September 13, 2021

Pearl High School Indoor Training Facility
Pearl, Mississippi

ADDENDUM NO. 03

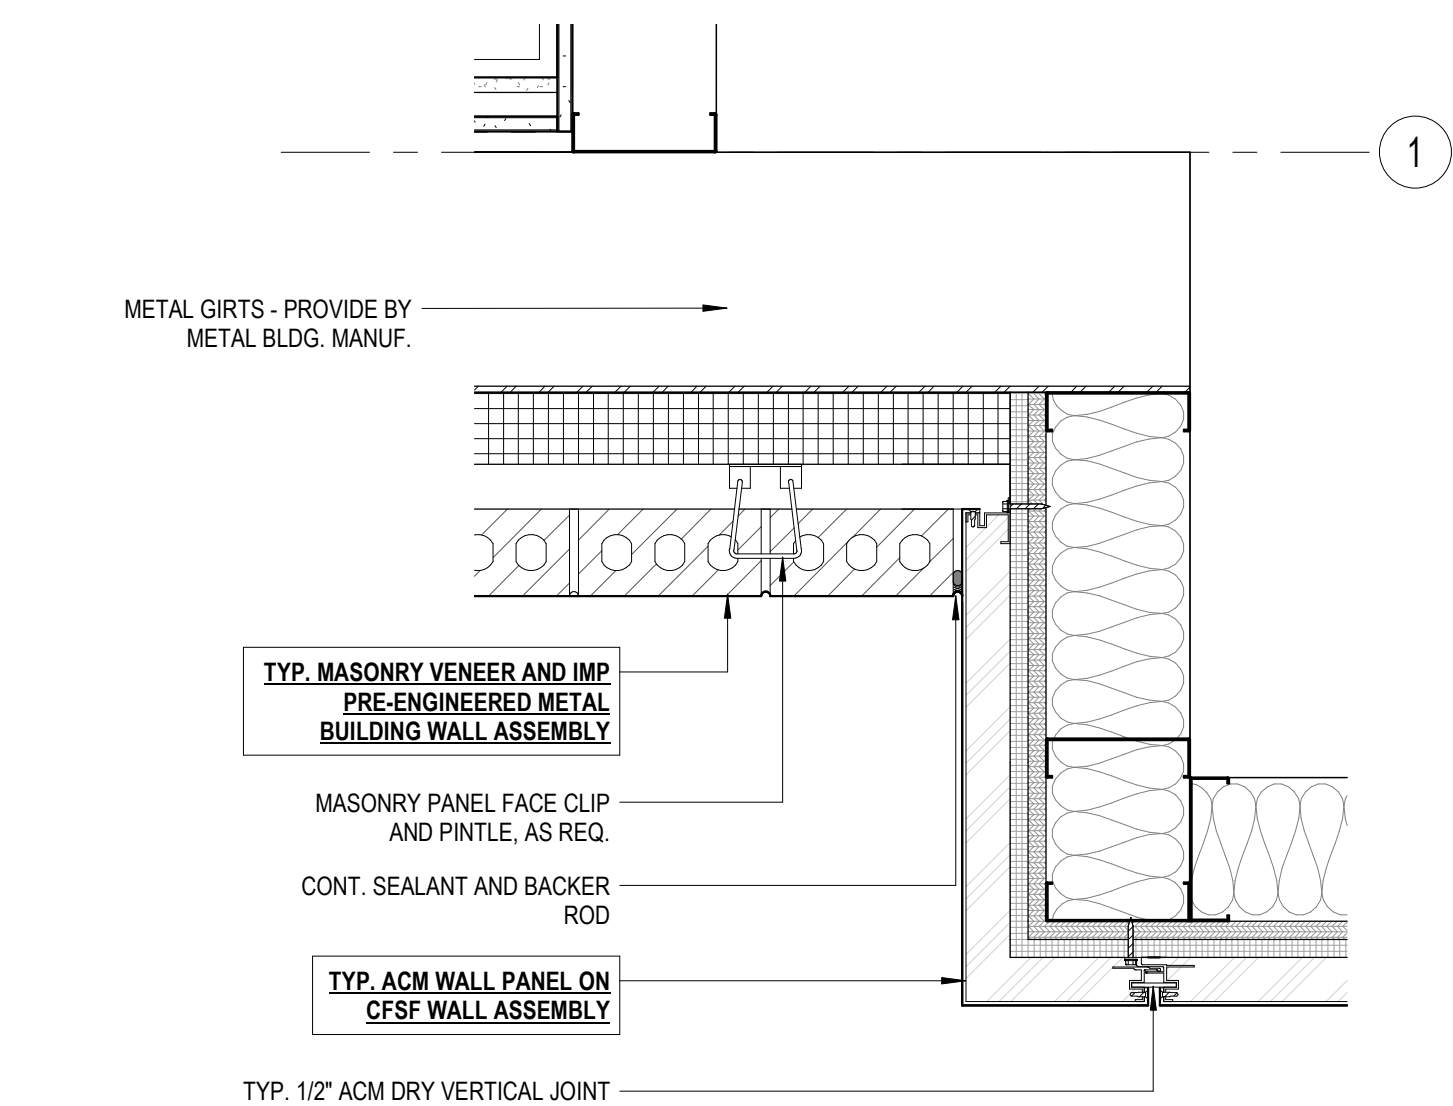
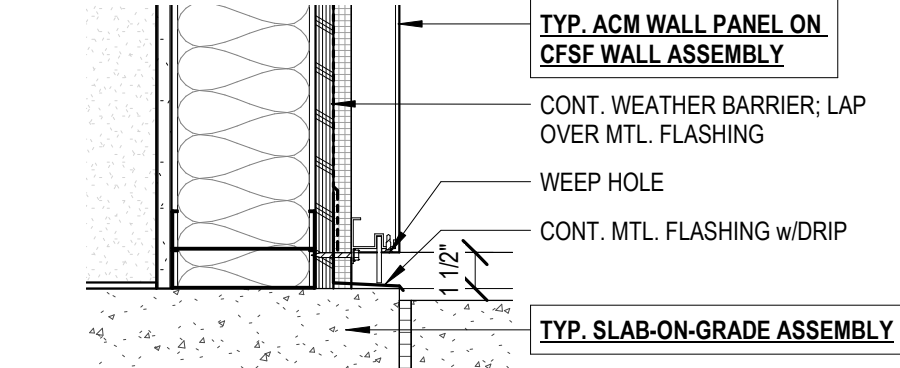
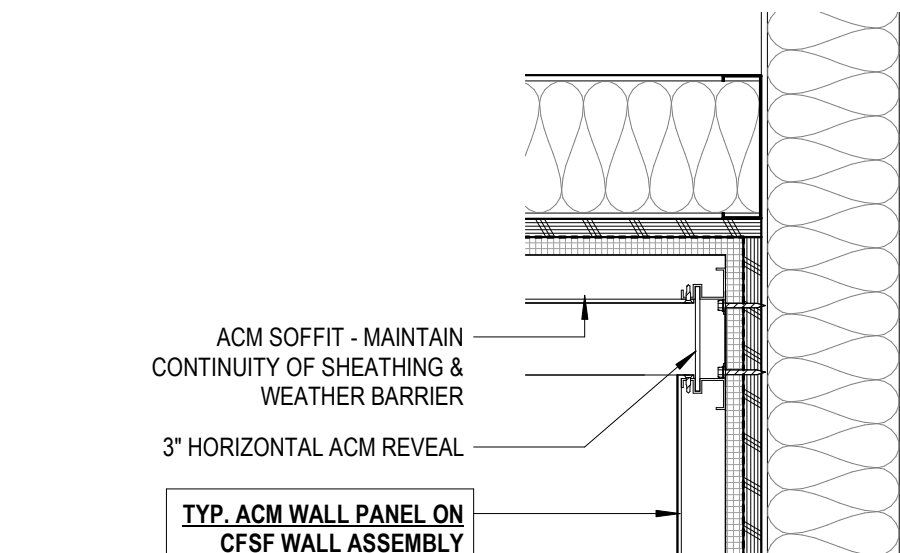
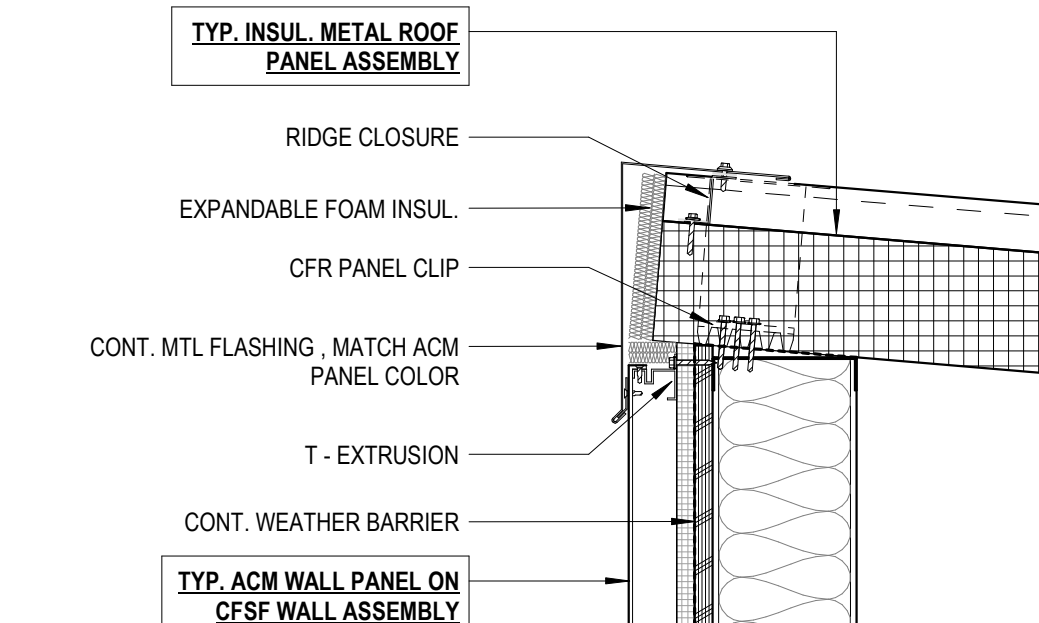
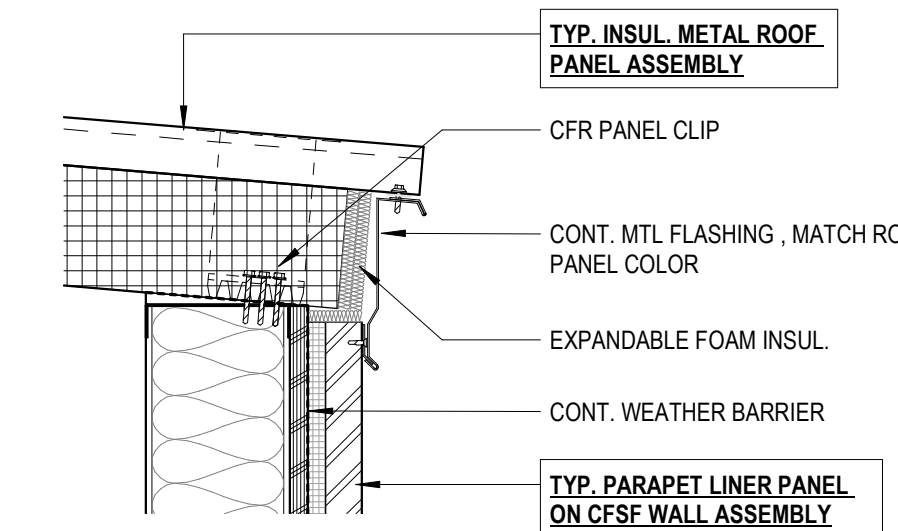
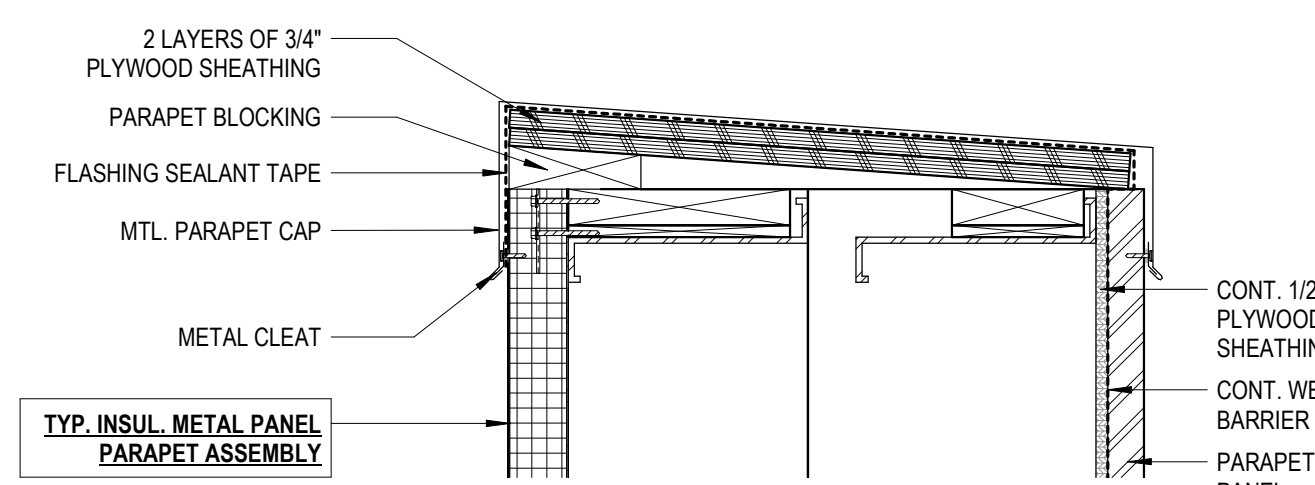
- ITEM NO. 04 A401 EXTERIOR DETAILS**
Revise per the enclosed sheet
- ITEM NO. 05 A501 DOORS & WINDOWS**
Detail #s 1 & 3 Window Sill Details
Add General note to read as follows:
 “ Wooden Sills and Aprons shall be paint-grade Poplar and shall have a painted finish.”

E1.2
PARTIAL LIGHTING
PLAN - PART B

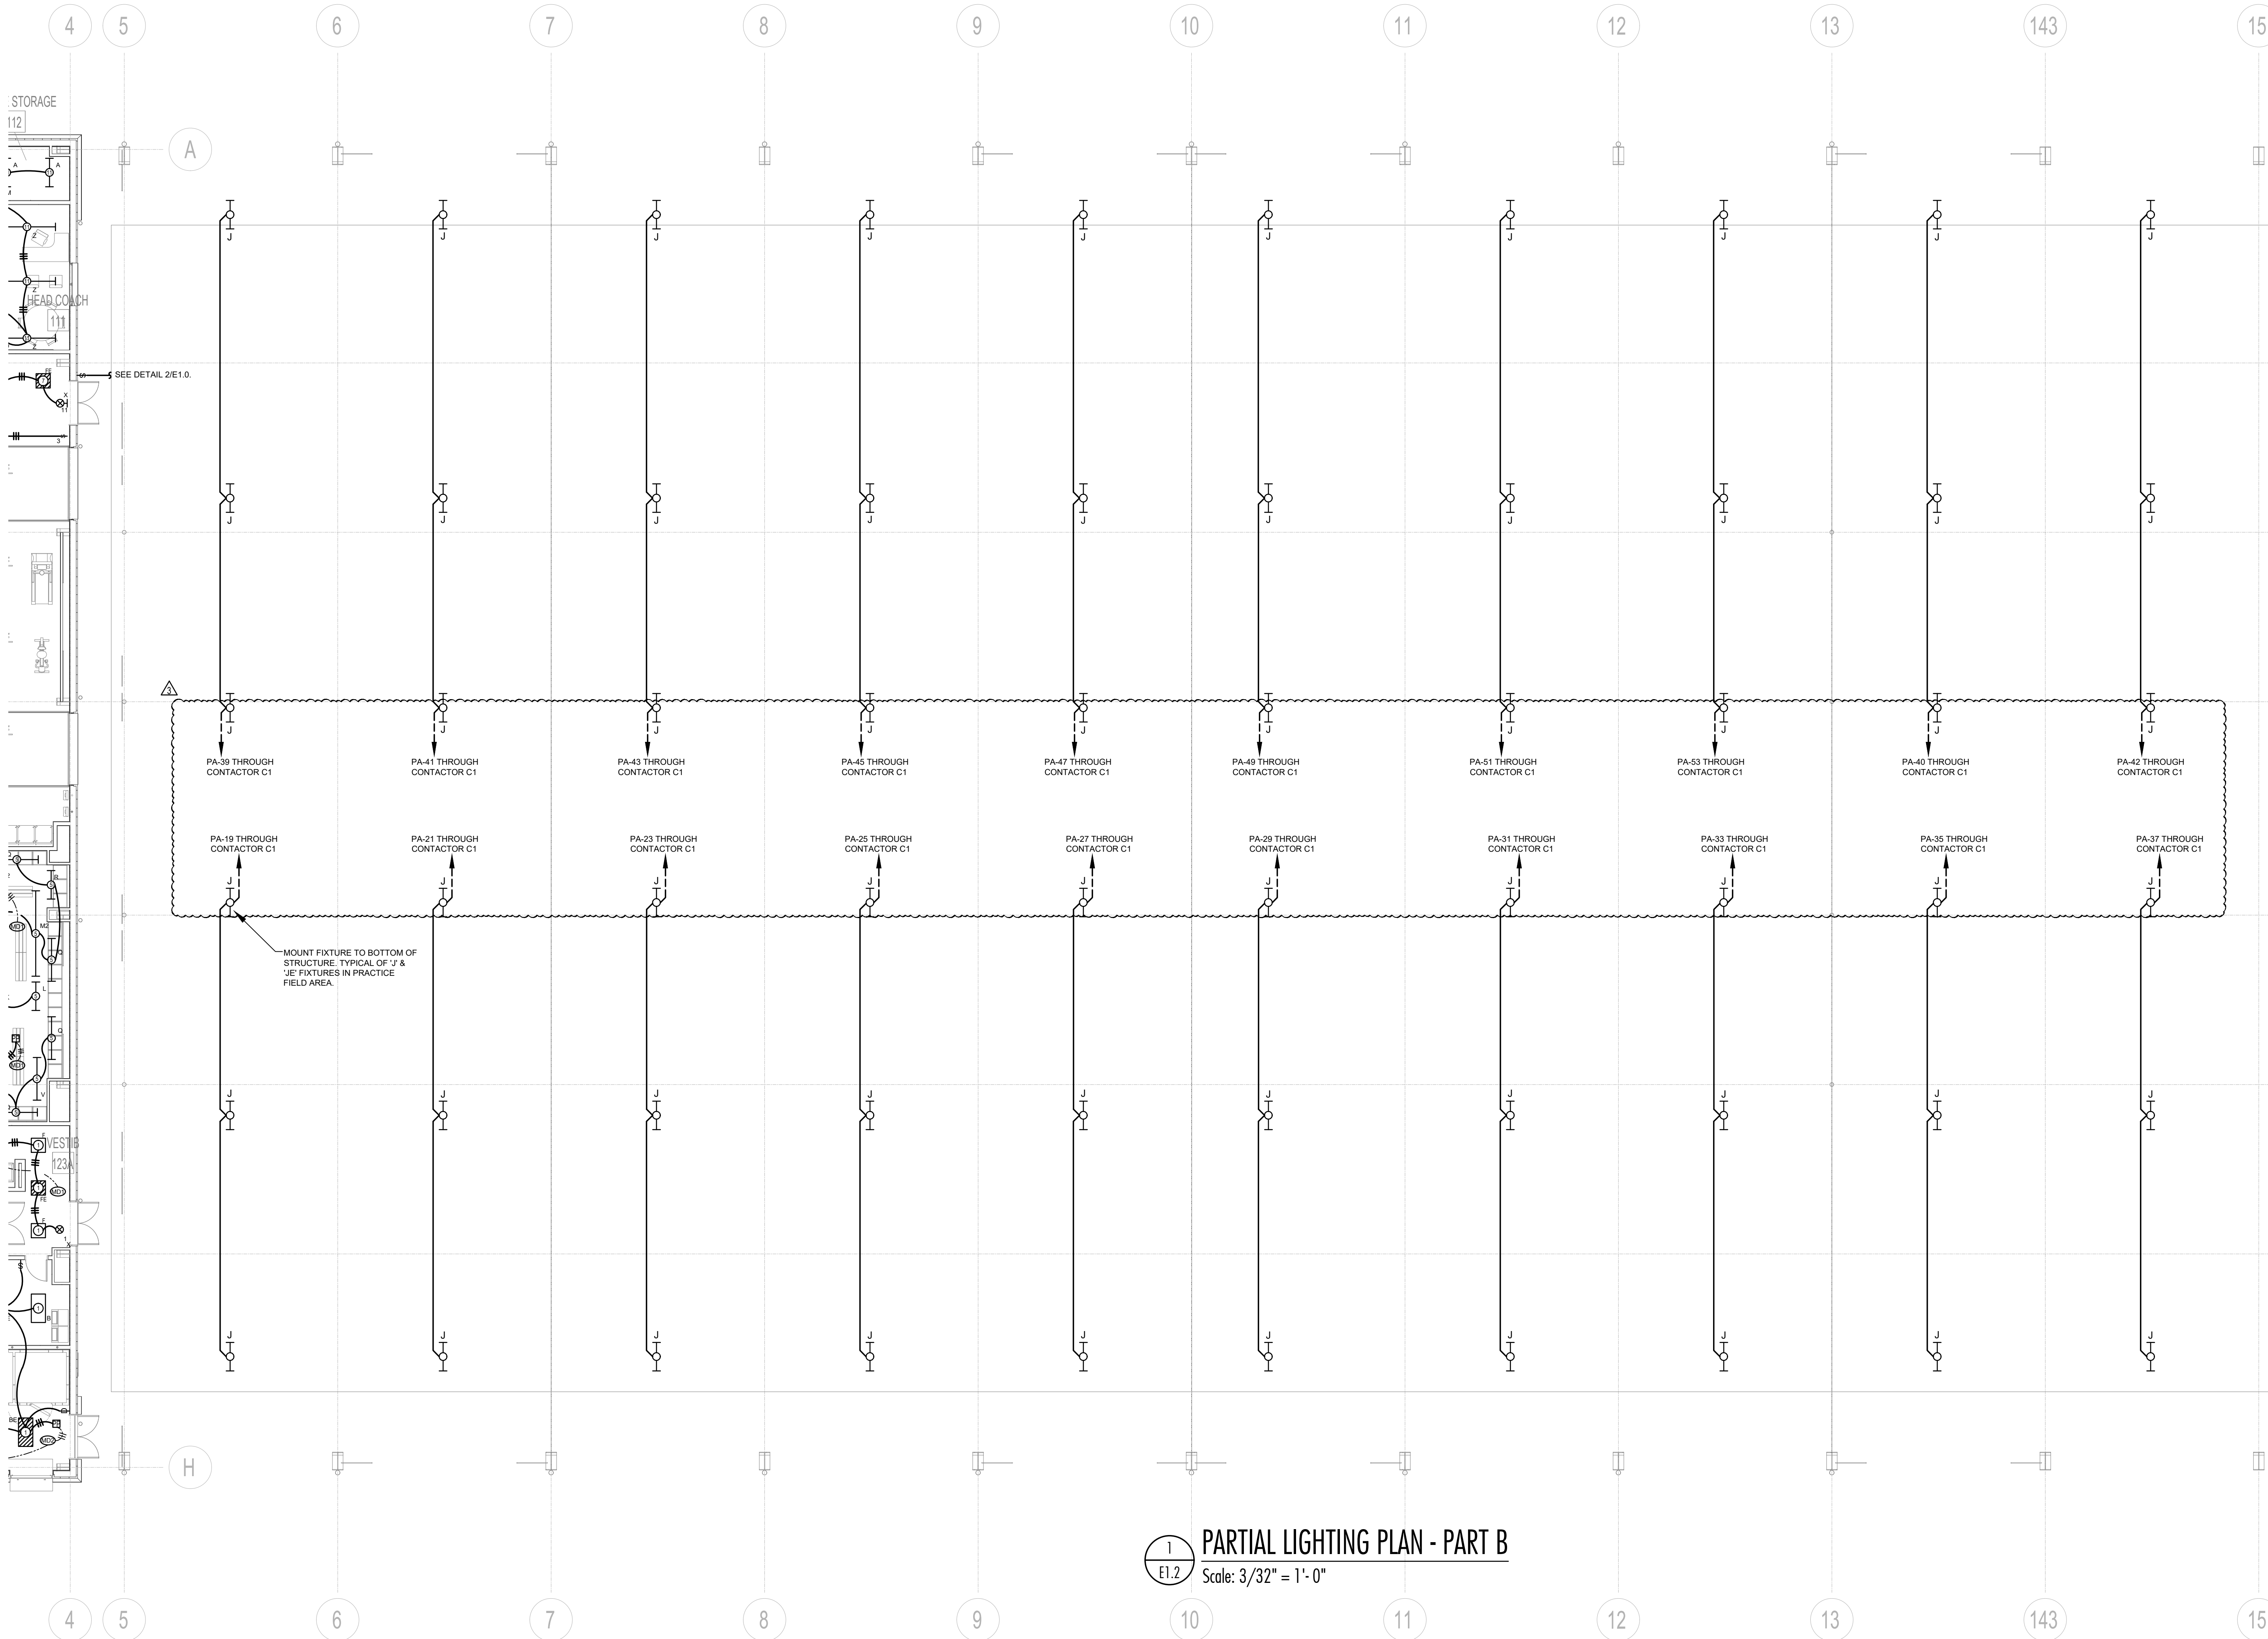
- ITEM NO. 09 E1.2 PARTIAL LIGHTING PLAN – PART B**
E2.2 PARTIAL POWER PLAN – PART B
Revise per the enclosed sheets
